P/F Suðuroyartunnilin

Peer Review and Second Opinion of Risk Analyses for Suðuroyartunnilin

Report

Report No.	H-FO-001
Revision	0
Date	11.10 2024
Prepared	Niels Peter Høj
Checked	Joan Qi Si
Approved	Niels Peter Høj

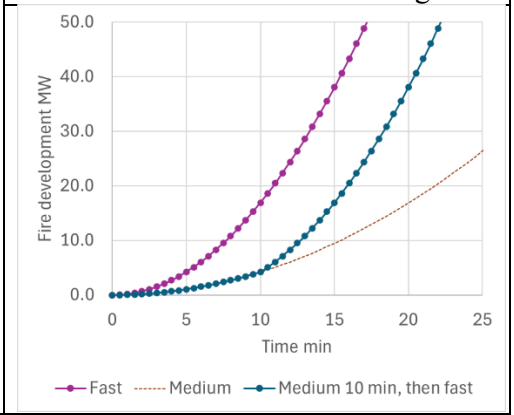
Distribution of Developed fires in HGVs in Suðuroy Tunnel:

Fire severity	Conditional probability (HGV)	Annual estimated probability	Return period [years]
1 MW	20%	0.0212	47
5 MW	31%	0.0329	30
25 MW	25%	0.0266	38
50 MW	16%	0.0170	59
100 MW	6%	0.0064	157
200 MW	2%	0.0021	471
all	**100%**	**0.1062**

The calculation presented by Norconsult in Tabell 6 gives shorter return periods and approximately 70% higher probabilities.
